## REQUEST

Current Zoning: O-1 (CD) (office, conditional)  
Proposed Zoning: R-12 MF (CD) (multi-family residential, conditional)

Approximately 9.042 acres located off District Drive between W.T. Harris Boulevard and Shorthorn Street in the University City neighborhood.

The petition proposes to develop a greenfield site in the University City area to permit up to 96 multi-family residential dwelling units (at an approximate density of 10.42 dwelling units per acre (DUA)).

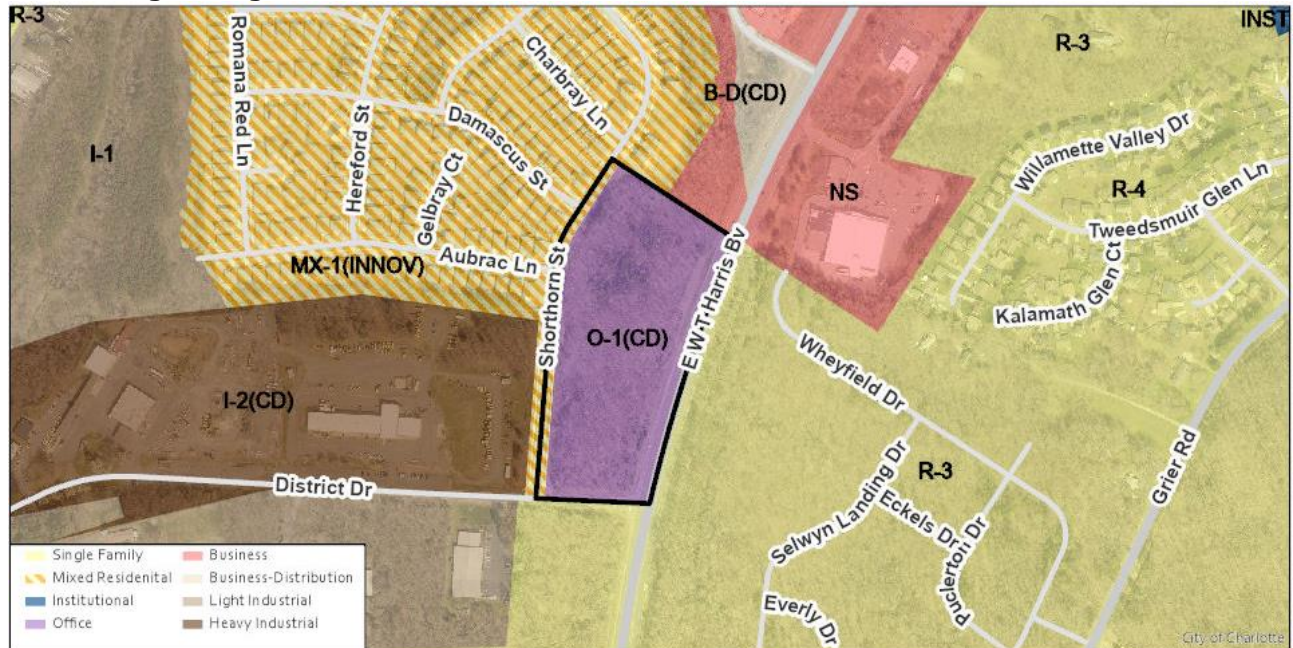
1. Revise site plan and conditional notes to commit to dedicate 35.6-foot minimum ROW from the centerline of Shorthorn Street and District Drive. The site plan shall label and dimension the ROW from the road centerline.

2. The proposed dwelling units exceeds 12 per acre. Per Chapter 20 Subdivision ordinance, site plan and conditional note revisions are needed to commit to construct an 8-foot planting strip and 8-foot sidewalk along Shorthorn Street. The wider sidewalk also meets Charlotte WALKS policy. The site plan shall label and dimension both items from the back of curb and gutter.

3. Add site plan note specifying dedication and fee simple conveyance of all ROW to the City before the site's first building CO is issued. CDOT requests rights-of-way set at 2-foot behind back of sidewalk where feasible.

4. Add a site plan note specifying that all transportation improvements will be approved and constructed before the site's first building CO is issued. The petitioner may phase transportation improvements if said improvements and phasing are explicitly described in site plan notes.

5. Petitioner should illustrate required tree save on site.
6. In Environmental Features, note that the site shall comply with the Charlotte Tree Ordinance.
7. GIS data indicated a 100-foot undisturbed PCSO across the site. Please show and label Potential 100-ft Undisturbed PCSO Buffer on the site plan.
8. Please include the following note under Environmental Features: "Development within any SWIM/PCSO buffer shall be coordinated with and subject to approval by Charlotte-Mecklenburg Stormwater Services and mitigated if required by City Ordinance. Petitioner acknowledges intermittent/perennial stream delineation reports are subject to review and approval upon submission of development plans for permitting and are not approved with rezoning decisions.

9. As this is a planned multi-family development, the min setback is 27-feet from back of full ROW along Shorthorn. Please revise plan and notes to reflect this.

10. Label/delineate all yards and setbacks sitewide. Pay special attention to the northeastern corner of the site where the buffer yard pinches in. The Class B buffer should extend the whole length of that property line.

11. Remove architectural table from page one (bottom right corner).
12. Remove FAR from development data table.
13. Edit max. height to reflect the height allowance in R-12MF.

14. Remove open space percentage from the development data table.
15. Please add all conditional notes to the rezoning site plan page.
16. Remove item 3, Optional Provisions, from the conditional notes. Not applicable.

17. Refine list of permitted uses and commit to architectural standards as the petitioner sees fit.
18. Remove Parks, Greenways, Open Space unless a commitment is being made to provide those amenities.

19. Remove section 10 from the conditional notes.
20. Revise signage section to state "signage shall be provided in accordance with the requirements of the sign ordinance".

21. Revise lighting comment to reflect commitment to fully capped detached lighting.
22. Remove section 13.
23. Remove section 14.

24. Remove architectural elevations.
